Town of Hilton Head Island
Regular Design Review Board Meeting
Tuesday, April 24, 2018 – 1:15 p.m.
Benjamin M. Racusin Council Chambers
AGENDA

Town of Hilton Head Island
Minutes of the Design Review Board Meeting
March 27, 2018 at 1:15 p.m.
Benjamin M. Racusin Council Chambers

DESIGN TEAM/DRB COMMENT SHEET

SHEET TITLE
FUEL STATION ELEVATIONS

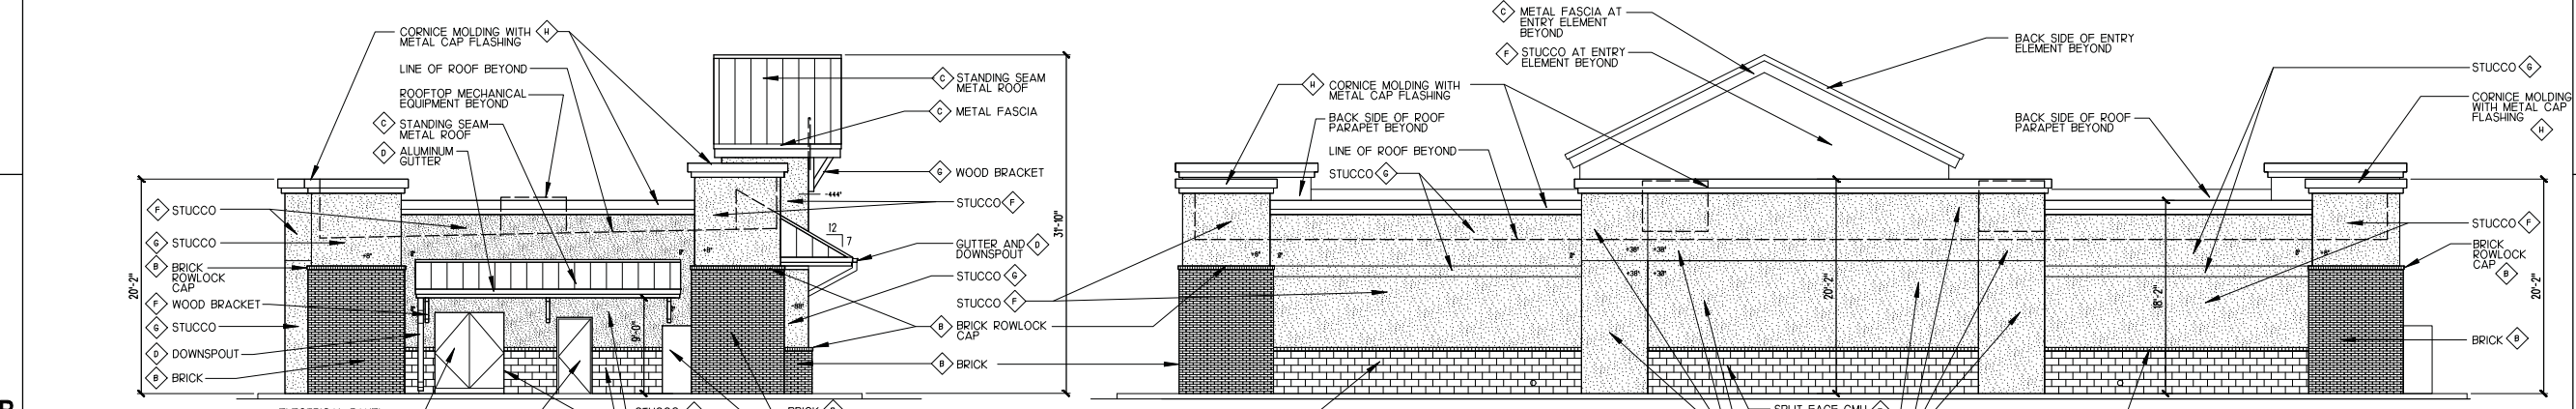
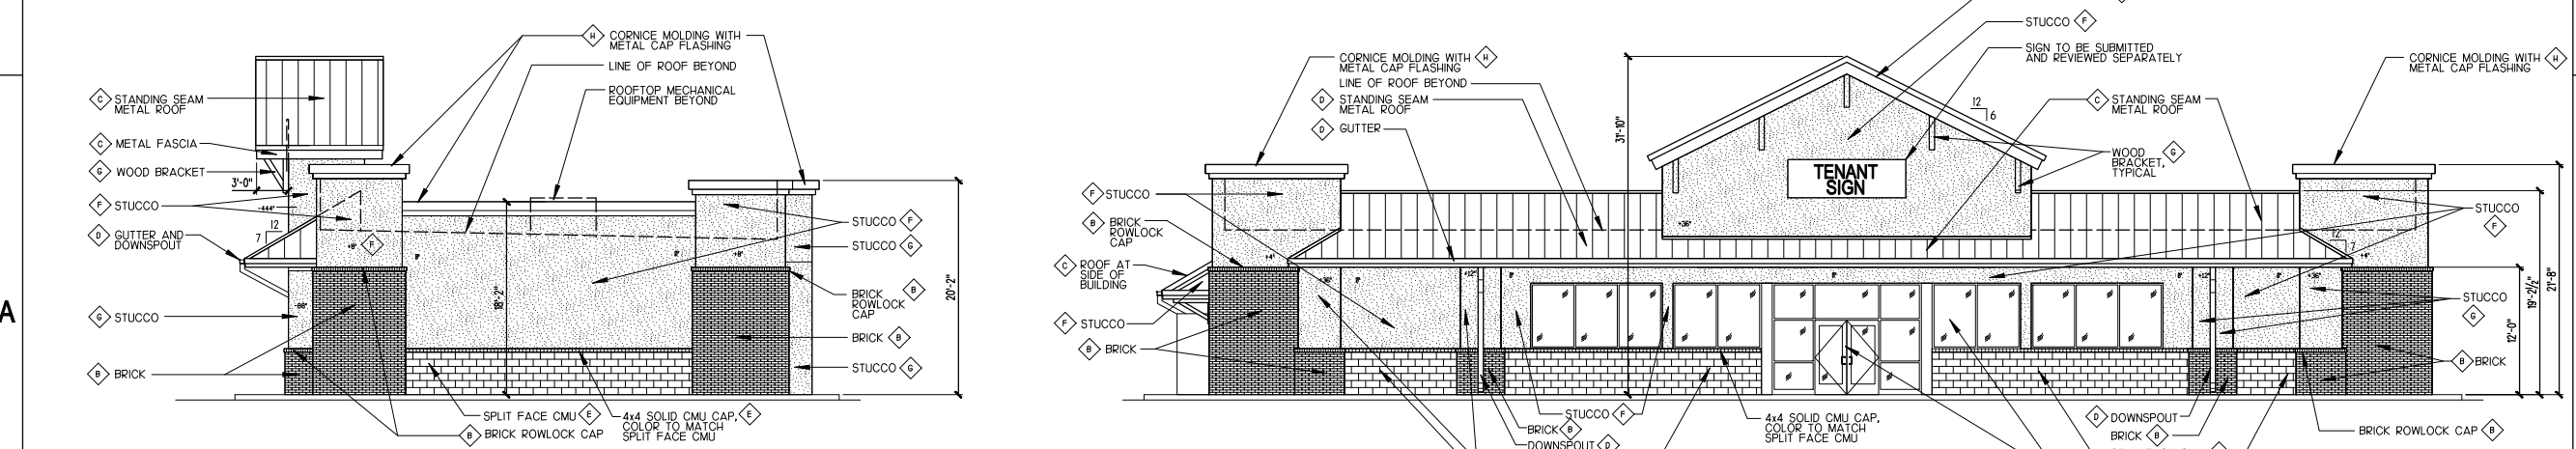
The Board made further comments and inquiries regarding: any roof elements are required to be identified and screened; consider improving signage to better identify the front entrance; façade signs cannot be above the roof eaves; reconsider the number of sconces or size and make sure the light source is only casting downward; the drive aisle at the drive-thru side shows bollards with light; find a more native species than Shell Ginger and Philodendron; include a bicycle rack near the front entry; consider providing brick or columns at the aluminum fence at the front; the entry side of the building proportion appears suitable; the drive-thru scale appears smaller; no architecture is proposed at the patio area at this time, only the extended roof overhang at the door area; consider adding more buffer plantings between the patio and the driving lane, and the median between the drive-thru and the existing driving lane; more room is needed between the 26" Live Oak and the curb; eliminate the planting near the trunk; and details on the propane tank and mechanical equipment are needed for final.

1 PHOTOMETRIC PLAN
SCALE: 3/4" = 1'-0"

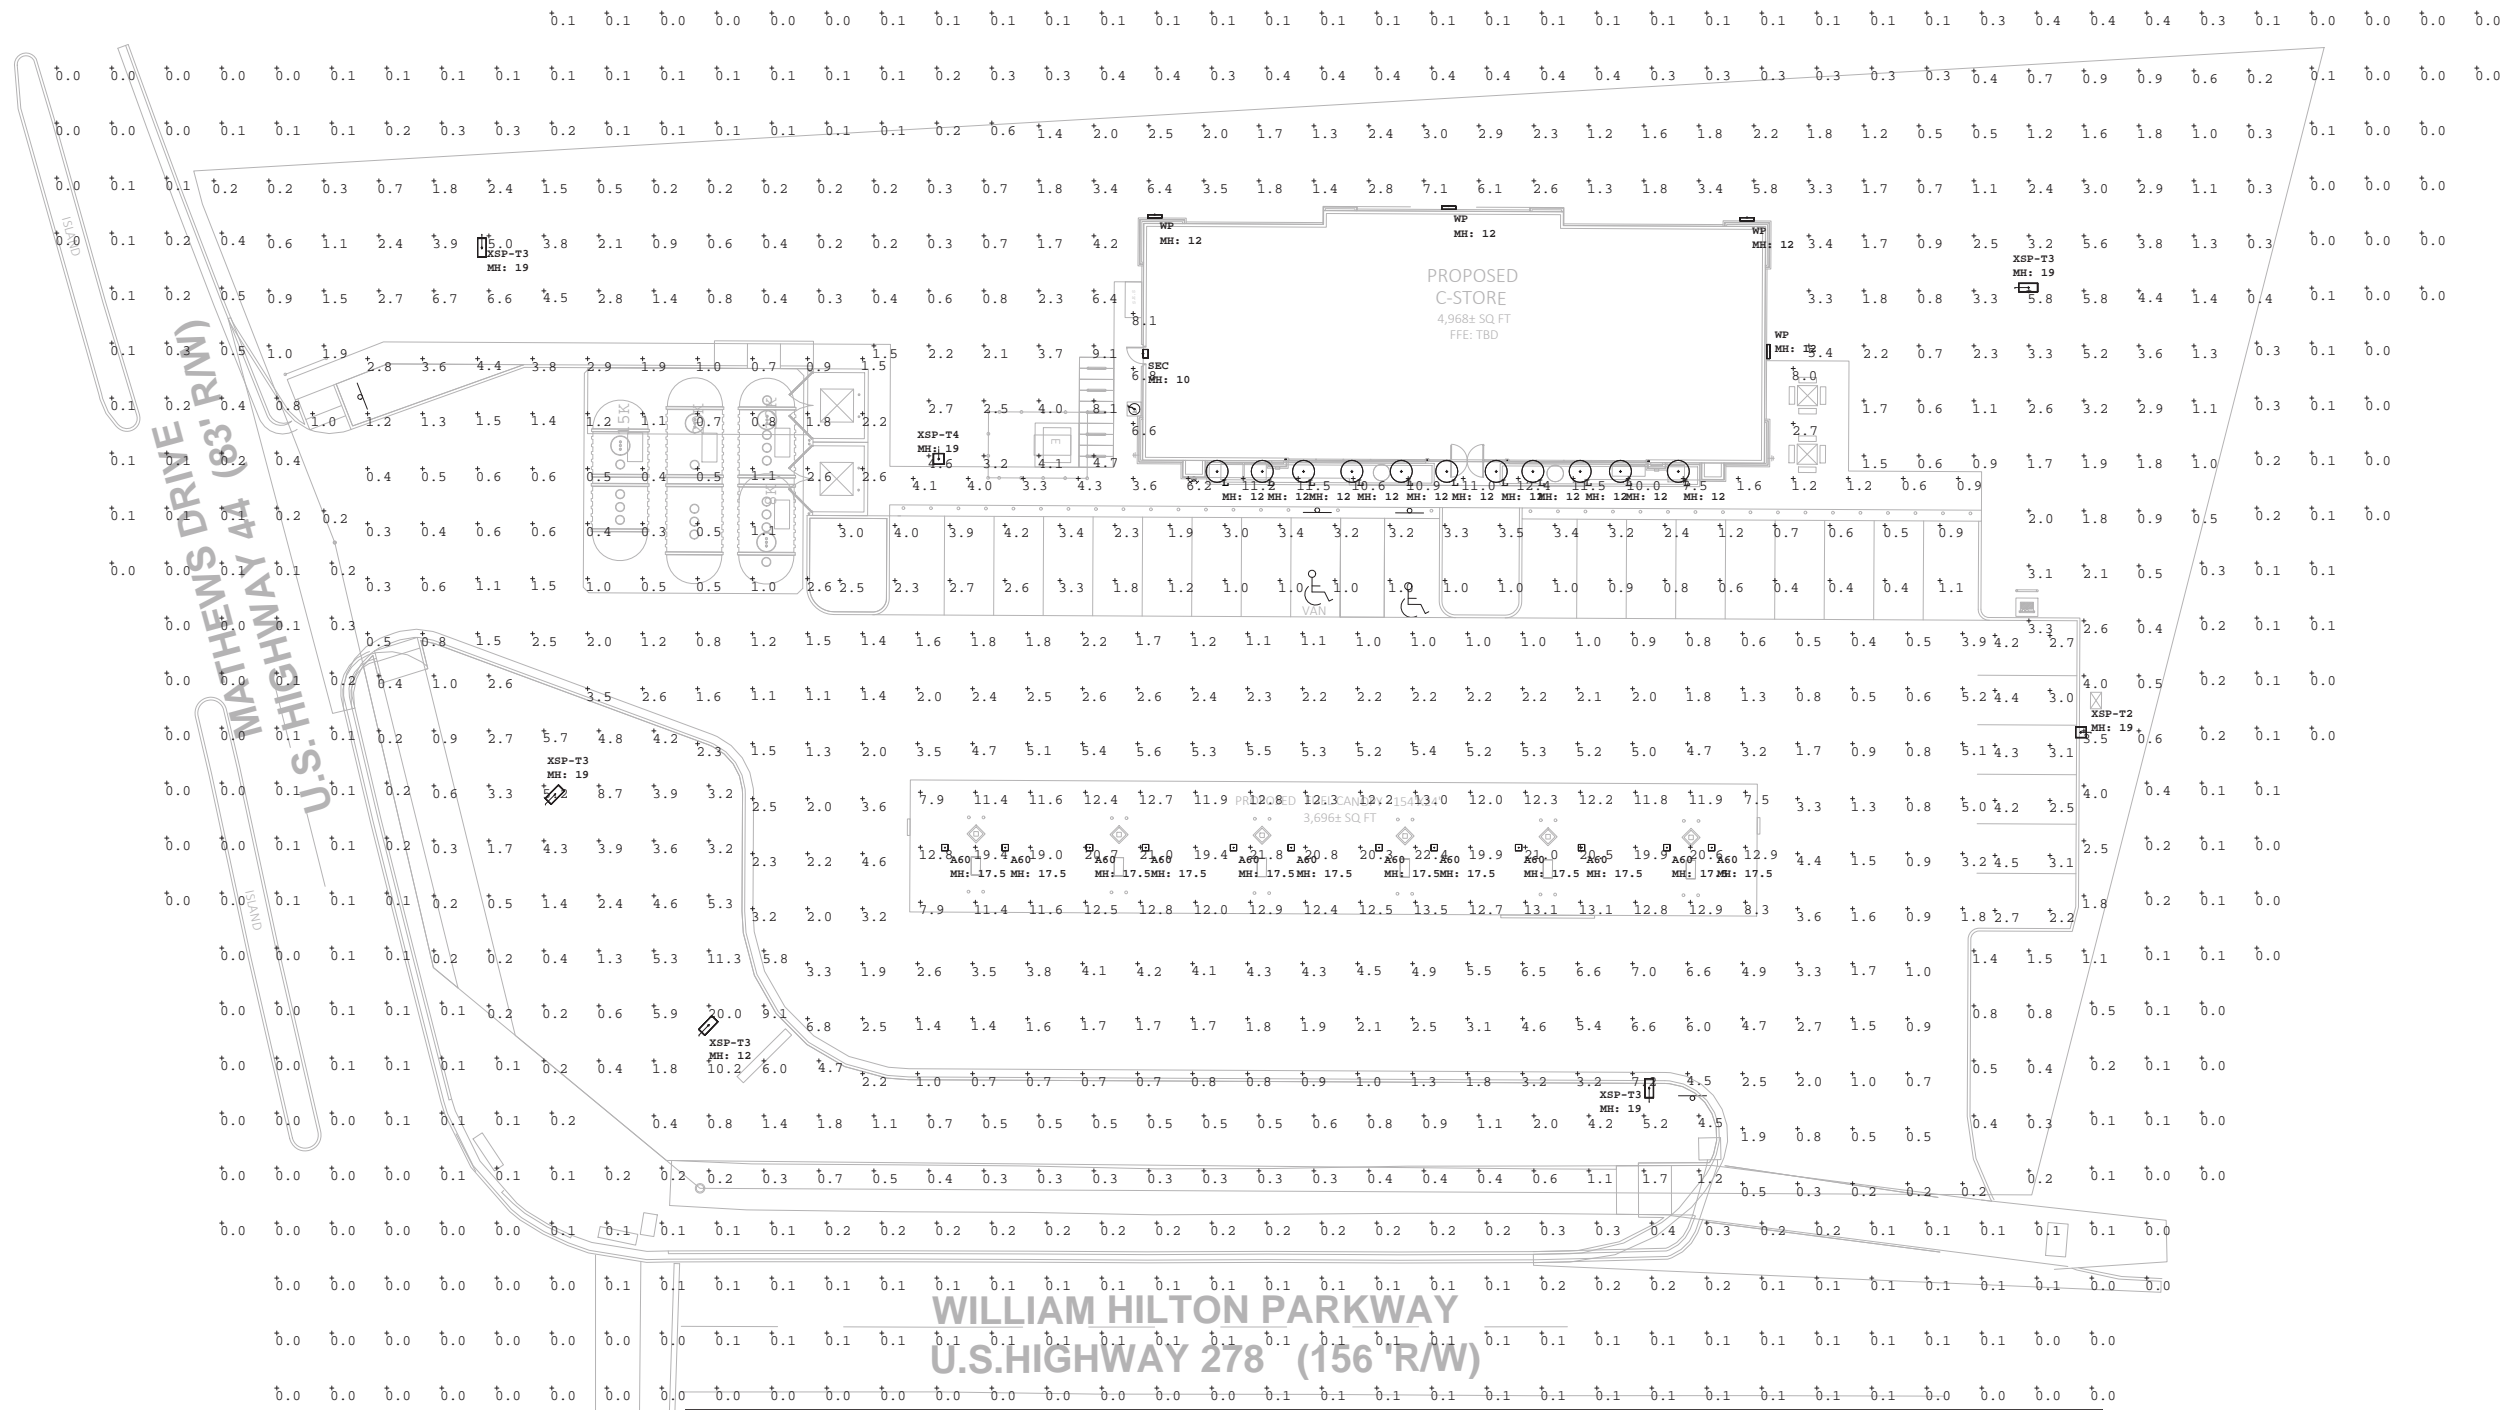
1. Lighting under the canopy exceeds the 12 foot candles allowed by the LMO.
2. Specify on the plans that all lights will not exceed 3000K.
3. Include shields on lights to prevent light from crossing the property line.
4. Specify bronze light fixtures and poles.
5. Staff suggest shifting the building forward to the corner of Hwy 278 and Mathews with the fueling canopy behind the building. This concept is currently being used at SeaTurtle Marketplace with the out building. <ul style="list-style-type: none"> a. This would improve the circulation for the fuel tankers, conceptually eliminating the "S" curve maneuver in-favor of a single arc. b. Customer vehicular circulation is unaffected. c. The corner of the site (currently unused) would be more useful. d. The allowed façade signs on the building would be more visible in addition to the allowed monument signs.
